# Product information - BMW brake pads | HELLA

## BMW brake pads

**8DB 355 009-271 / 8DB 355 015-391**

## New allocation of the brake pads

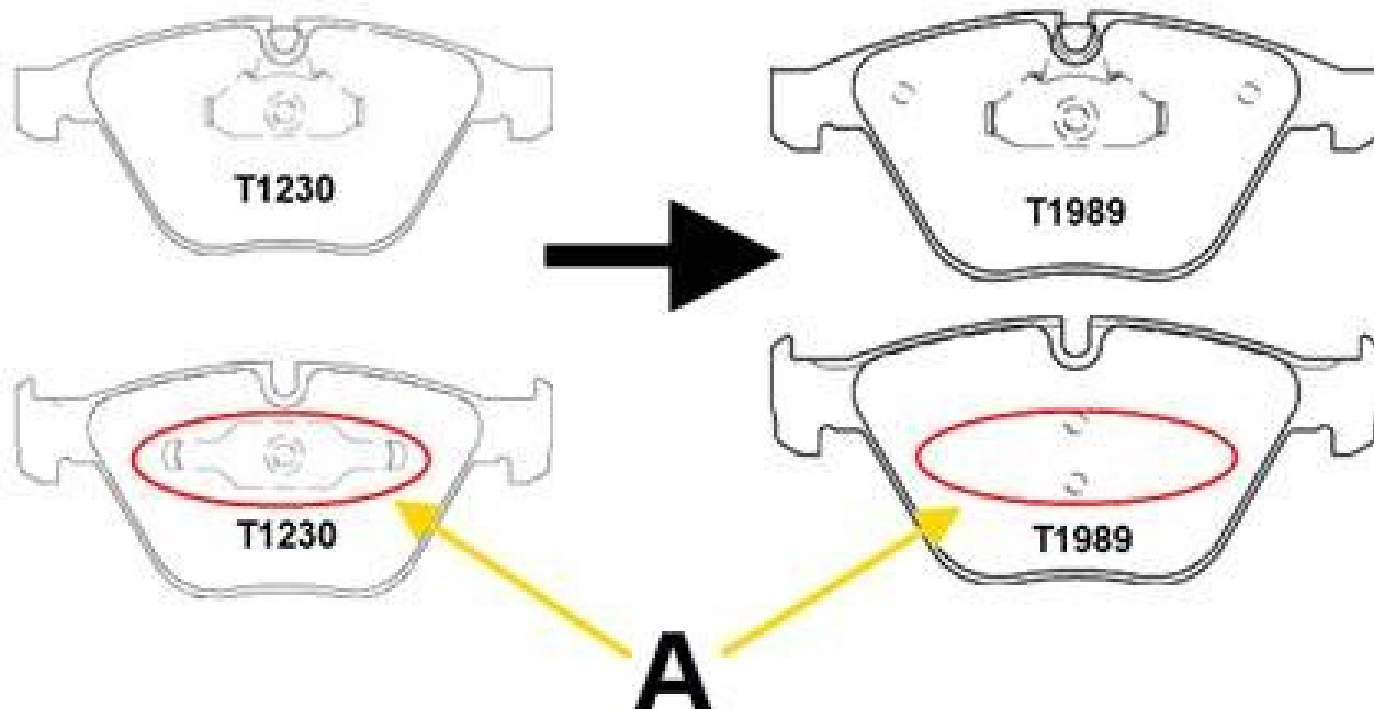
The difference between both brake pads is the missing retaining spring (A) on the brake pad 8DB 355 015-391 / T1989 on the fist side.

All other models are now covered by 8DB 355 015-391 / T1989. 8DB 355 015-391 / T1989 can also be retroactively used for all vehicles linked.
